UNITED STATES PATENT AND TRADEMARK OFFICE

| Office Action Summary | Application No. 10/519,772 | Applicant(s) FUCHS, ERNST | |

DETAILED ACTION

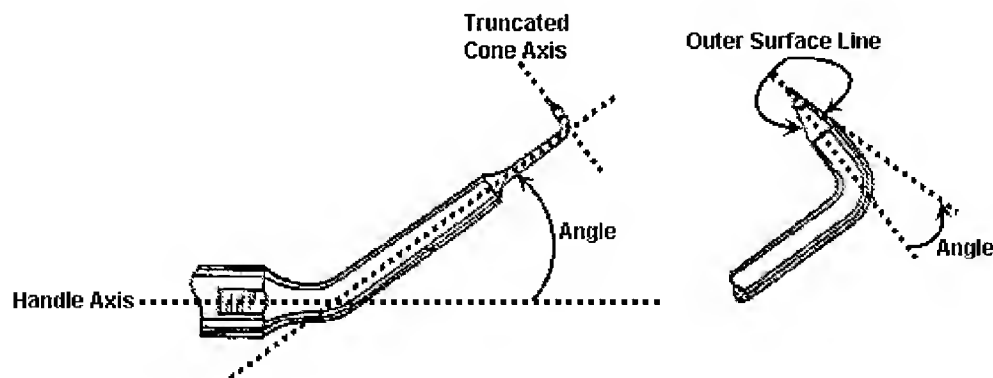
Carr discloses a surgical instrument (Figure 1) comprising a drilling element (30) having a spinous shape (i.e. www.medicaldictionary.thefreedictionary.com defines the term spinous as pertaining to an object that has the shape of a spine or thorn) and a truncated cone (58) having a closed, solid tip (59; i.e. flat and rotationally symmetrical relative to an axis of the truncated cone) with an outer surface line that is smooth and encloses an angle of no more than several degrees with the axis of the truncated cone; and a handle (22) at an angle to the axis of the truncated cone with the spinous shape of the drill element enclosing an angle with the handle, wherein the drilling element and the handle are non-coaxial positioned relative to one another (see annotated Figure below, Figures 1 and 3-3A and column 3, lines 24-65 and column 4, lines 17-32).
